Access Compliance Report

Public Rights-of-Way

Intersection ID: 42747	Main Street: ASHLEY_MEADOW_DR	Cross Street: BARCLAY_FOREST_DR	Location: S
ADA ID: 550570A6C58D	Ramp Type: PerpDiag	Initial Pass/Fail: Fail	Overall Compliance: No
Severity Score: 30			
Codes/Mitigation Info/Possible Solution		Field Measurements/Component Compliance

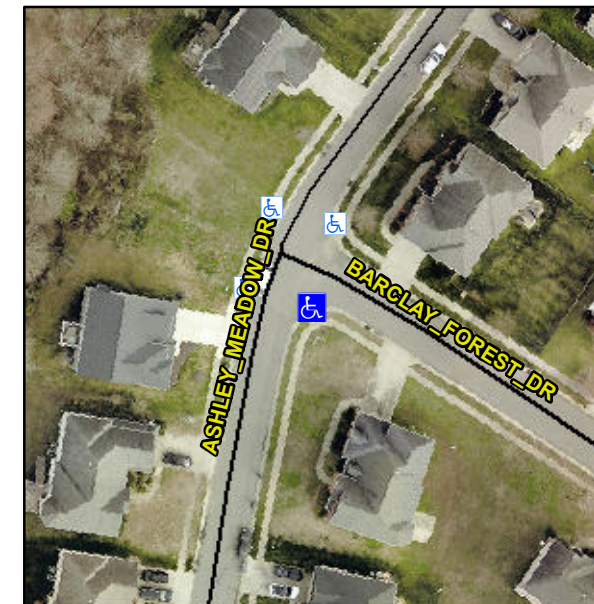
Not Found, R304.5.1, R304.5.3

Compliance	Description	Data	Compliance	Description	Data
N/A	Ramp Length (in)	46.5	Yes	Ramp Slope (%)	8.0
No	Ramp Width (in)	35.0	No	Ramp XSlope (%)	5.2
N/A	Flare Type LT	N/A	N/A	Flare Type RT	N/A
N/A	Flare Slope LT (%)	N/A	N/A	Flare Slope RT (%)	N/A
N/A	Flare Traversable LT?	N/A	N/A	Flare Traversable RT?	N/A
N/A	Landing Length (in)	N/A	N/A	DWS Provided?	N/A
N/A	Landing Width (in)	N/A	N/A	DWS Contrast?	N/A
N/A	Landing Slope (%)	N/A	N/A	DWS Length (in)	N/A
N/A	Landing X Slope (%)	N/A	N/A	DWS Full Width?	N/A
N/A	Landing Curb? (Y/N)	N/A	N/A	DWS Offset (in)	N/A
N/A	Shared Landing?	N/A			
N/A	Gutter Ponding?	N/A	N/A	Gutter Slope (%)	N/A
N/A	Gutter Lip Ht (in)	N/A	N/A	Gutter X Slope (%)	N/A
N/A	Painted X Walk1?	No	N/A	Painted X Walk2?	No
	X Walk 1 Direction	To E		X Walk 2 Direction	To W
N/A	X Walk 1 Width (in)	N/A	N/A	X Walk 2 Width (in)	N/A
	X Walk 1 Slope (%)	2.0		X Walk 2 Slope (%)	1.2
	X Walk 1 X Slope (%)	4.9		X Walk 2 X Slope (%)	2.4

Remove & Replace Curb Ramp With Two New Directional Ramps or Equivalent.
